M E M O R A N D U M

TO: Casey Adragna, Adragna Architecture
FROM: Elizabeth Steward, Associate Planner- Development Review
DATE: 6/18/26
SUBJECT: Douglas 234 Multitenant, Site Plan
Review Comments 04

LOT 10B, DOUGLAS 234 FILING NO. 6, AMENDMENT 2
HORSE CREEK COMMERCIAL SITE PLAN
LOCATED IN THE SW 1/4, SE 1/4, SECTION 29, T6S, R66W, 6TH P.M.
TOWN OF PARKER, COUNTY OF DOUGLAS, STATE OF COLORADO
PAGE 1 OF 15

FIRST FLOOR PLANS
DOUGAS 234 FILING NO. 6, AMD. 2
DATE: JUNE 8, 2026

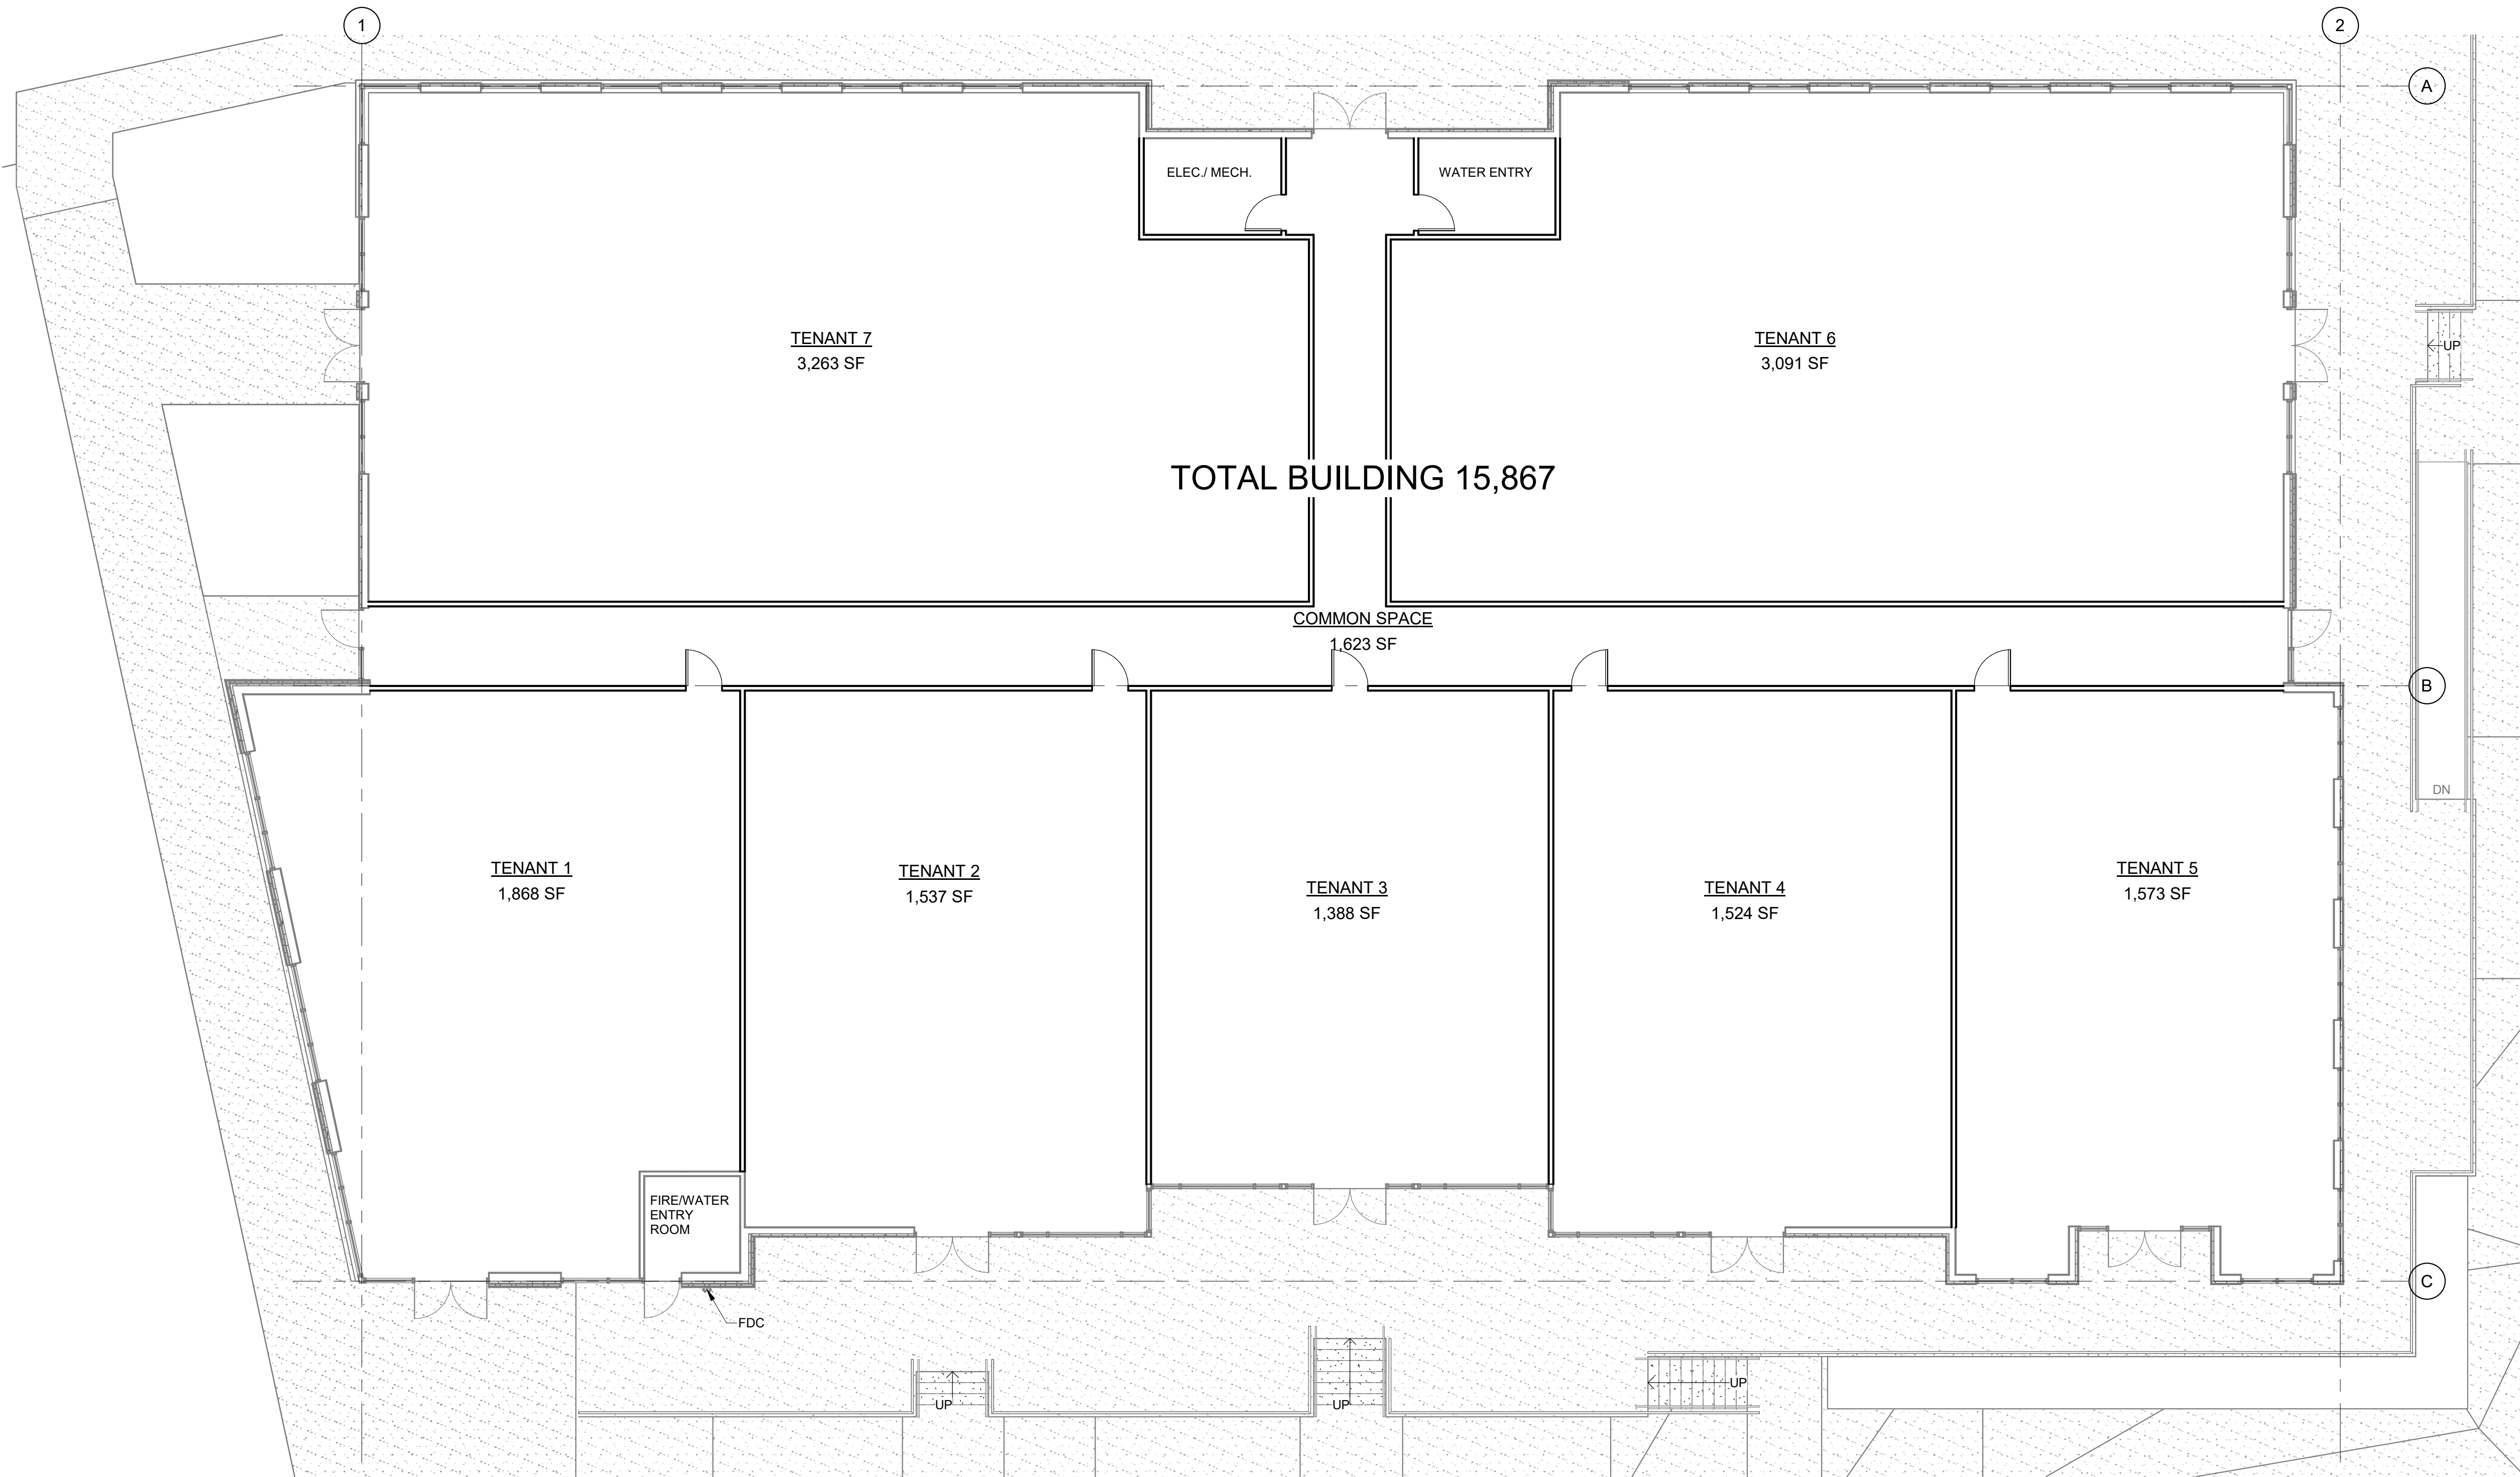
Do you know if the previous planner sent out for a building address/ let you know of a proposed address? If not, please let me know and we will get that handled in the next review cycle.

No, I do not believe that an address has been assigned. Please help with request for a building proposed address.
